To all users of the following systems: Cios VA30

Product/Trade Name:	Cios Spin, Cios Alpha, Cios Flow	EU-SRN E-mail	DE-MF-000006122
UDI-DI:	04056869153506, 04056869153490, 04056869246628	Date Corrective Action ID	September, 2023 AX036/23/S

Customer Safety Information (CSI) for Field Safety Corrective Action

Subject: Fulfillment of new requirements from DIN and IEC standards for Cios VA30 Systems

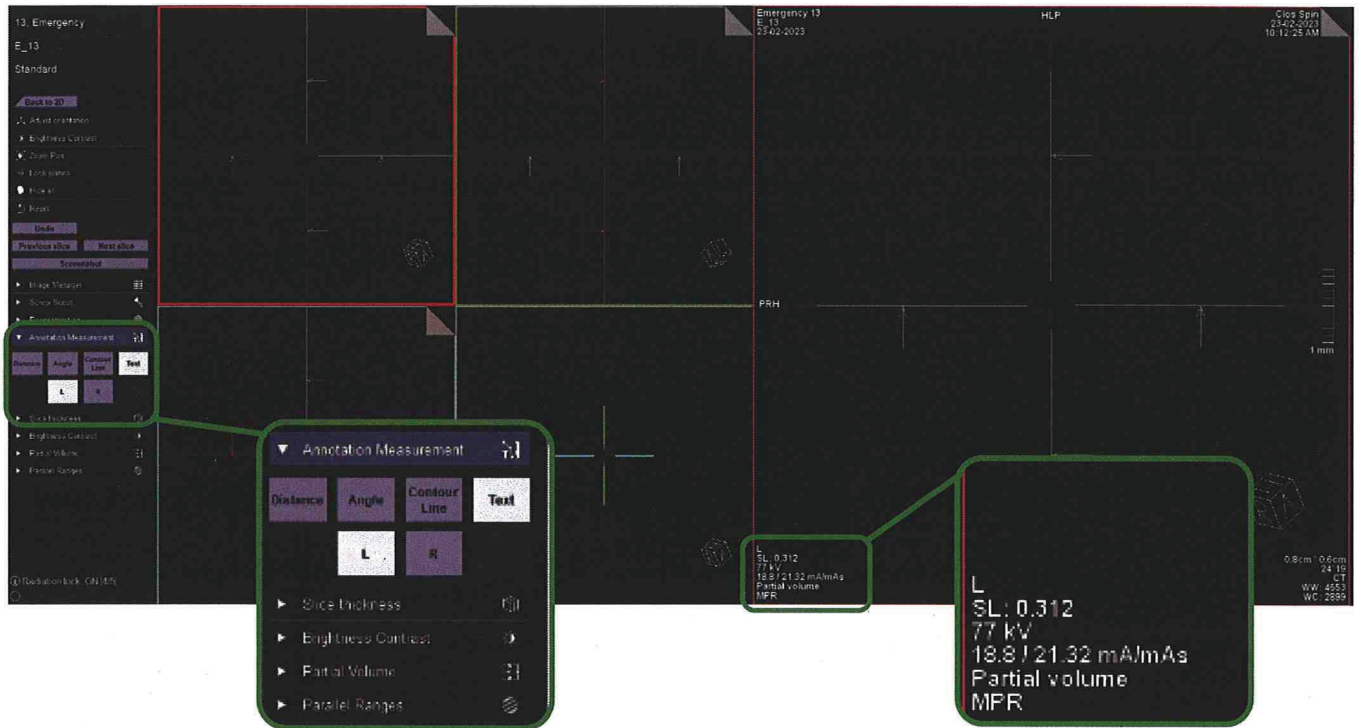
With software version VA30K, the user interface of Cios VA30 systems will be changed to consider the current standards DIN 6862-3 and IEC 60601-2-54.

In 3D mode and if patient orientation information is important in a procedure, the user can predefine the patient orientation "L/R" (left/right), and therefore "laterality" information will additionally be saved in the clinical image (see screenshot of user interface below).
